# Staff Summary Report

**SUBJECT:** Hold a public hearing for a Planned Area Development Overlay and Development Plan Review for 707 SOUTH FOREST

**DPR09066 -** Development Plan Review including site plan, building elevations and landscape plan.

SK#  
 A1.0A

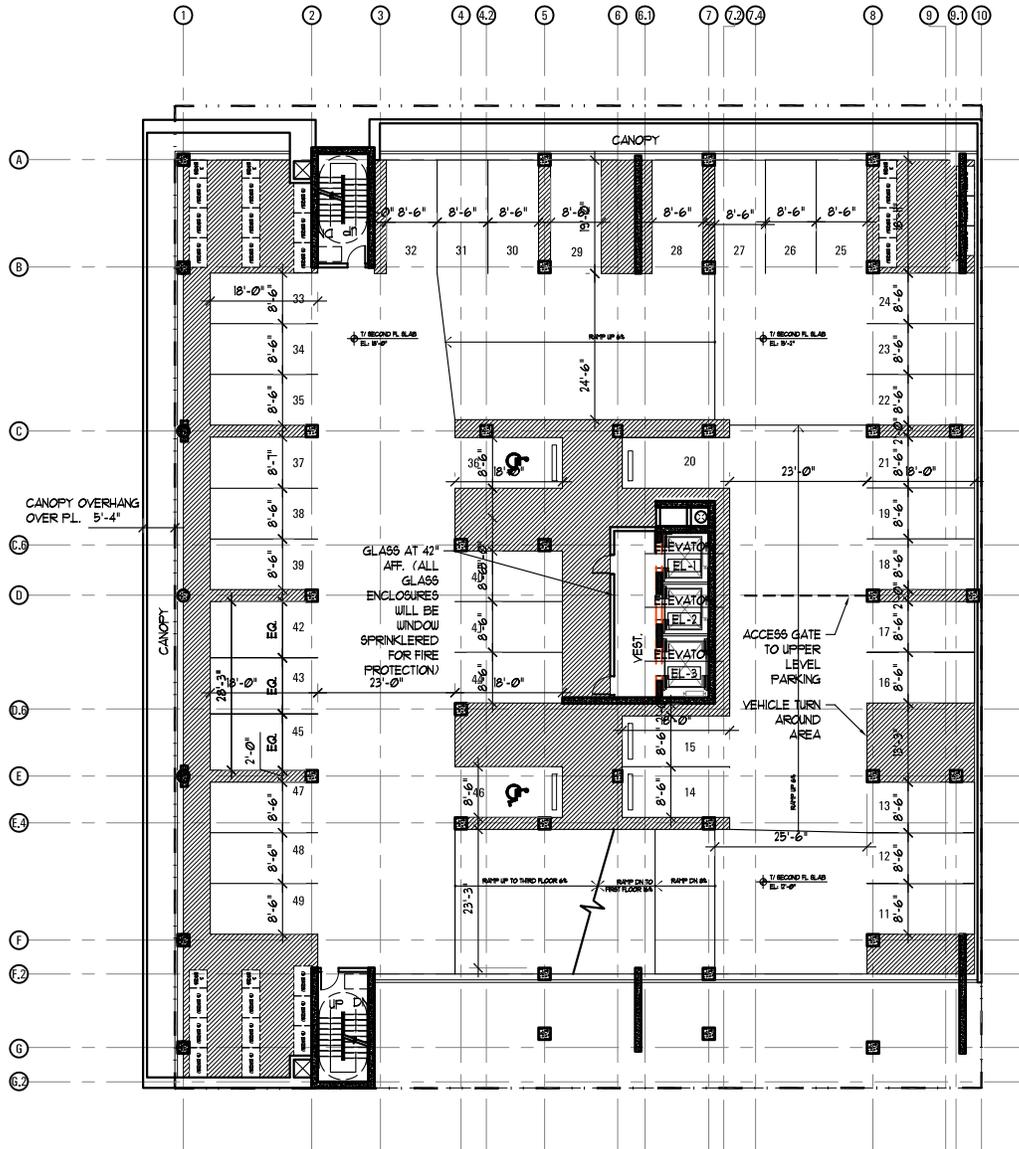
- Reconcile wire mesh screen and vine with ventilation requirements for structured parking.
    - Shear walls on floor plans interfere with southeast ground level exit door and refuse enclosure access adjacent to the alley. Resolve this conflict. Refer to sheet A1.0

DRAWING  
SIXTH FLOOR PLAN

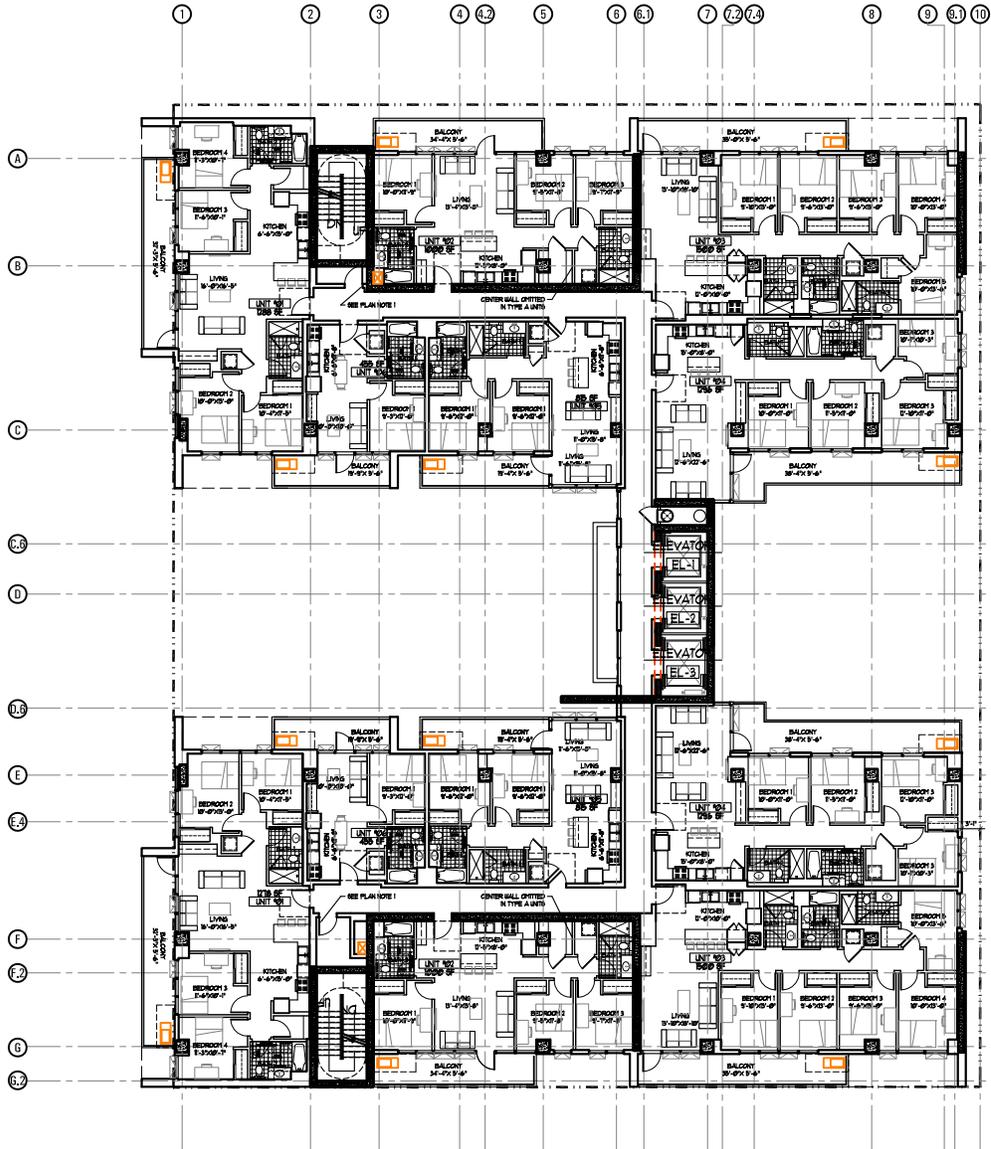
- b. Relation of landscape and hardscape areas as indicated on 6<sup>th</sup> Floor Plan, sheet A1.2 are acceptable. Indicate plant and/or sport surfaces in landscape areas.
